SERVICE BULLETIN

No. Q98 under BRAKES

CHASSIS AFFECTED ALLENTOWN ☒ HAYWARD ☐ OAKVILLE ☒**DISC BRAKE SUPPORT BRACKET**
(M35AX and MP404X Off-Highway Models)

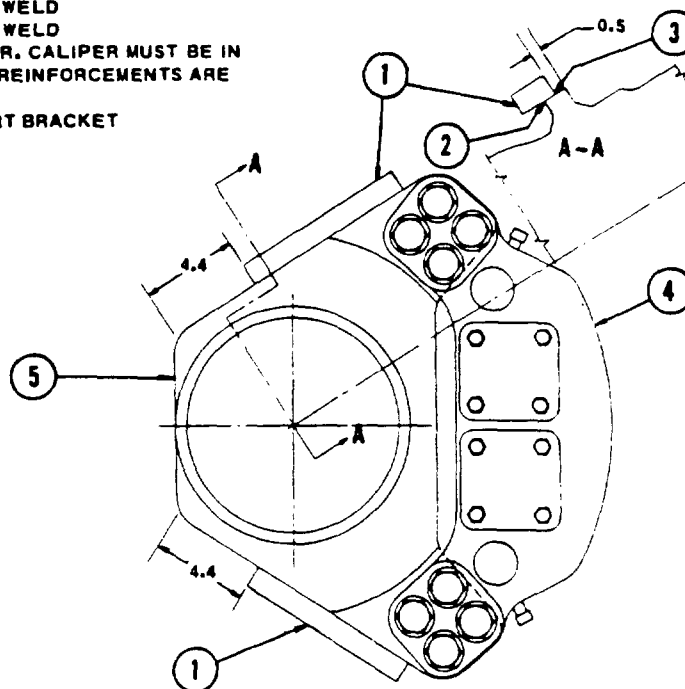
INFORMATION It has been found desirable to strengthen the brake support bracket on M35AX rear brakes and both front and rear brakes of the MP404X. This is done by welding a reinforcement plate to each side of the support bracket in the caliper mounting area.

The following illustration shows details for installing the reinforcement plates. Note that the brake caliper must be mounted on the bracket during the welding operation to prevent warpage of brake mounting surfaces.

1. REINFORCEMENT 71RU 13075. (1.0" X 1.75 X 8.0 CARBON STEEL)
LOCATE INBOARD FROM OUTER FACE OF SUPPORT BRACKET,
USING DIMENSION SHOWN.
2. 3/8 IN. FILLET WELD
3. 1/2 IN. FILLET WELD
4. BRAKE CALIPER. CALIPER MUST BE IN
PLACE WHEN REINFORCEMENTS ARE
WELDED.
5. BRAKE SUPPORT BRACKET
